LINCOLN COMMUNITY CENTER
FEASIBILITY STUDY PLAN
03/23/2024

SCHEMATIC DESIGN PLAN
07/24/2024

LINCOLN COMMUNITY CENTER

WHAT CHANGED?

FEASIBILITY STUDY CAMPUS PLAN 03/23/2024

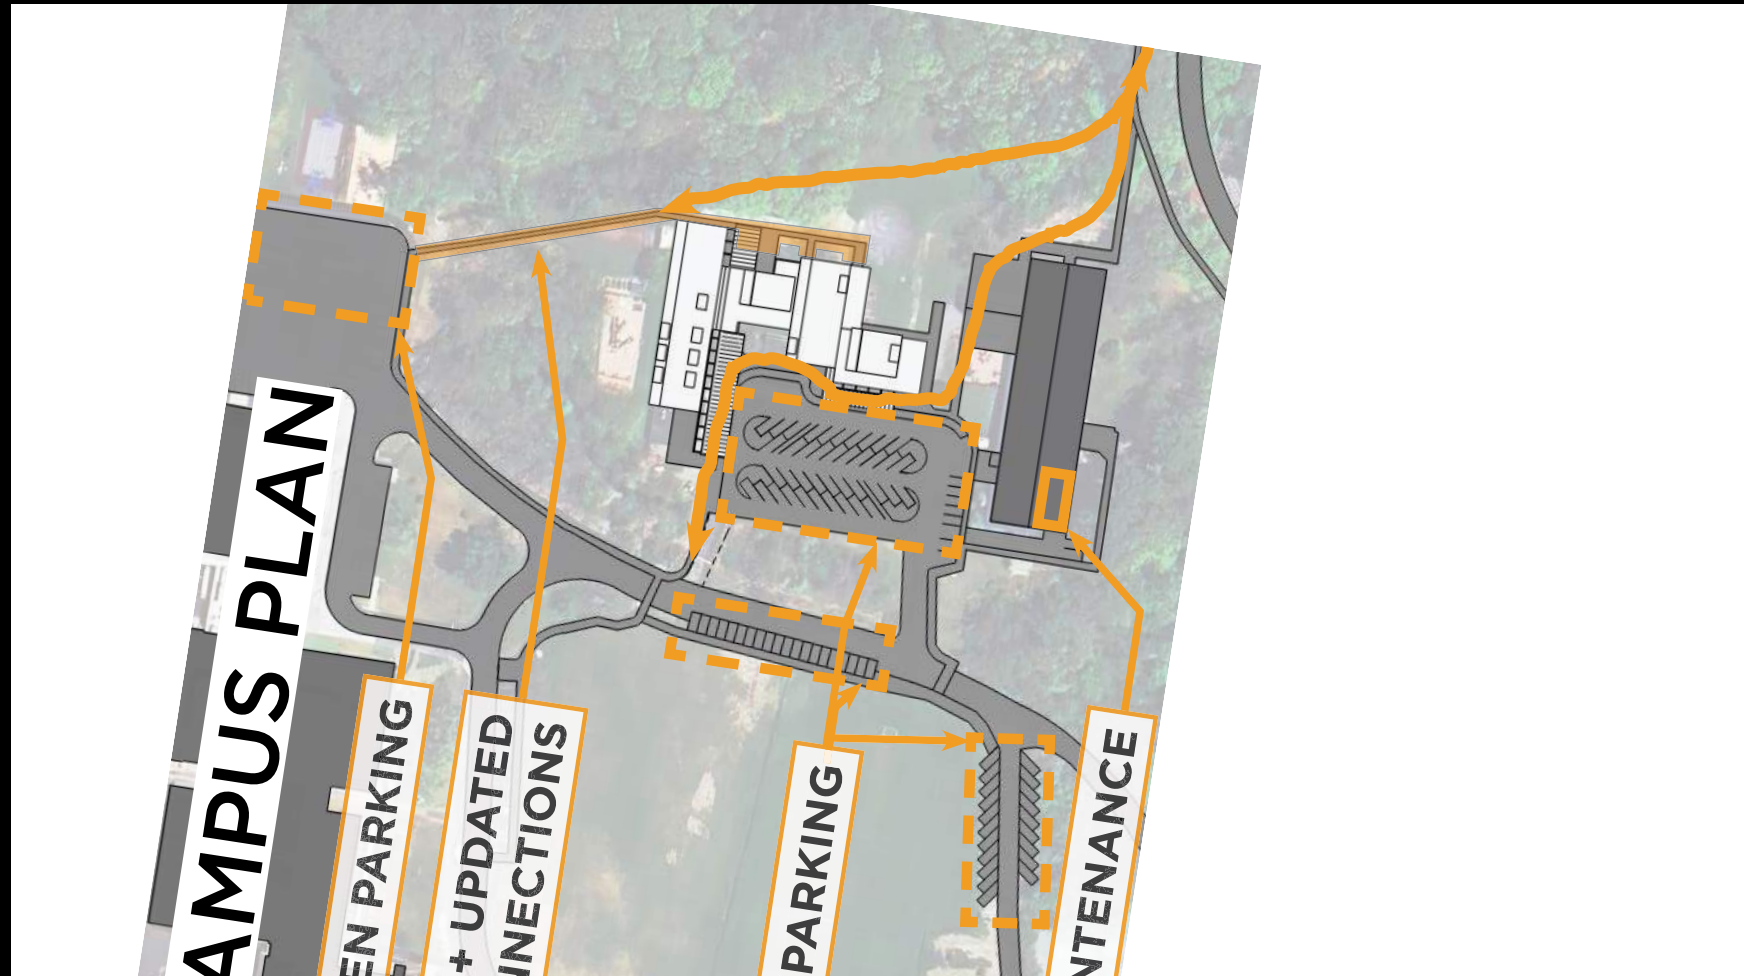
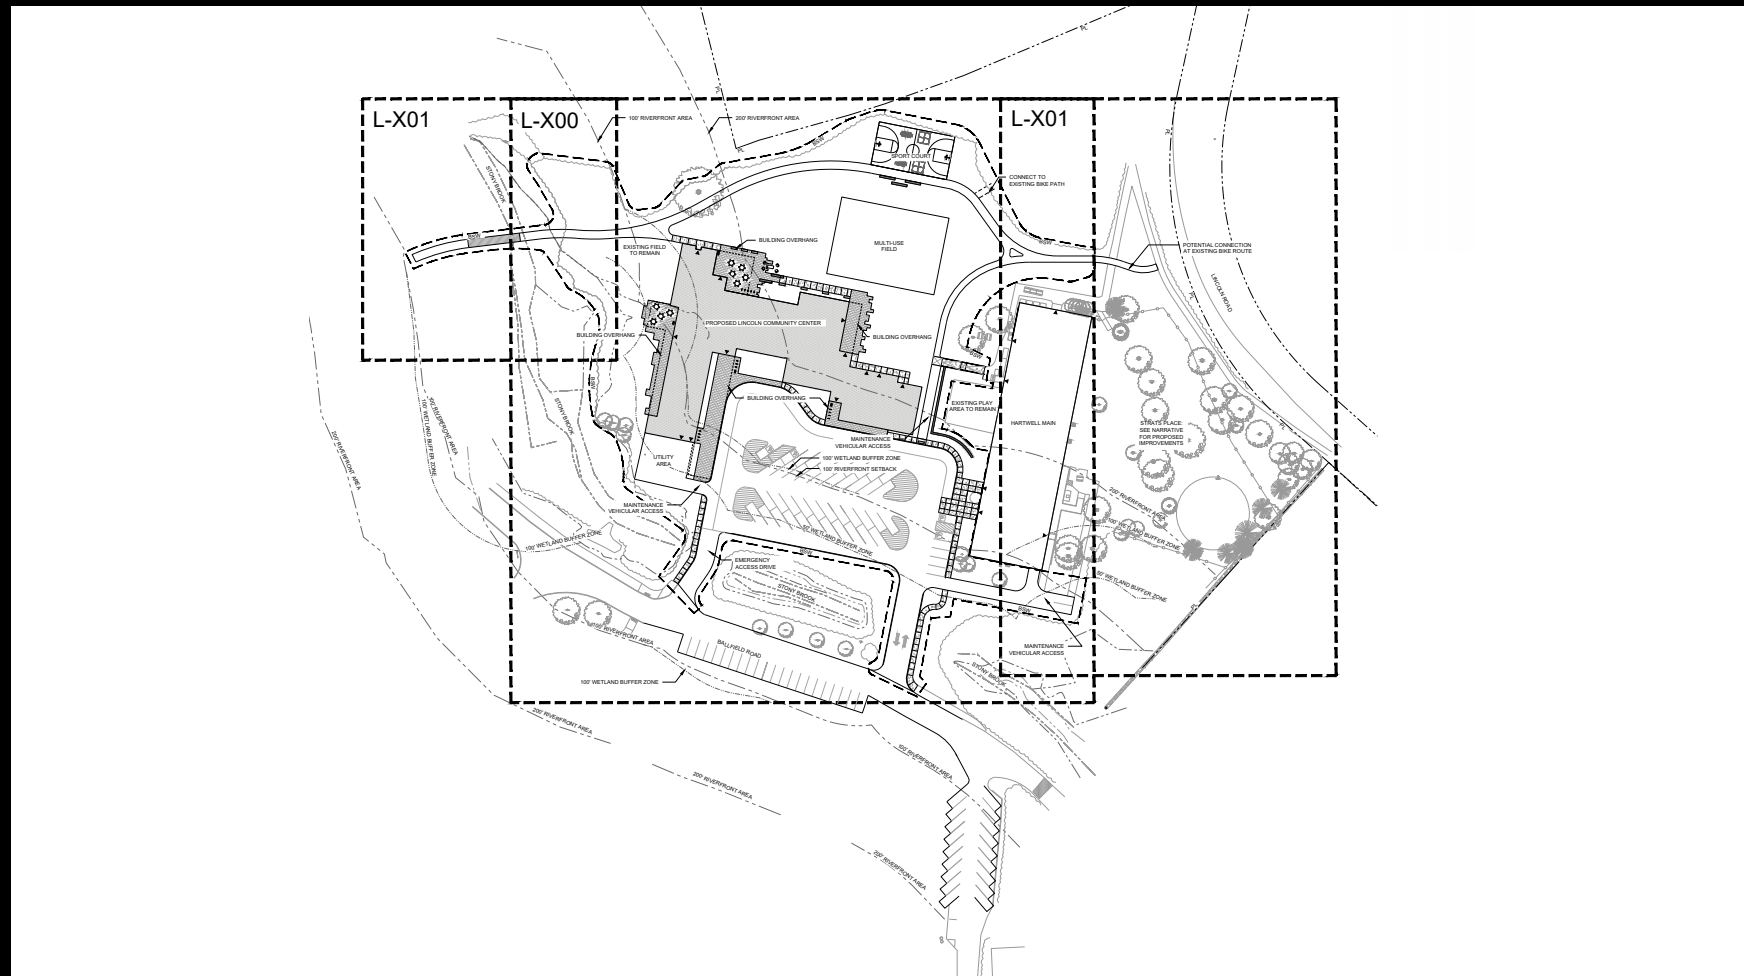
**SCHEMATIC DESIGN
CAMPUS PLAN
07/24/2024**
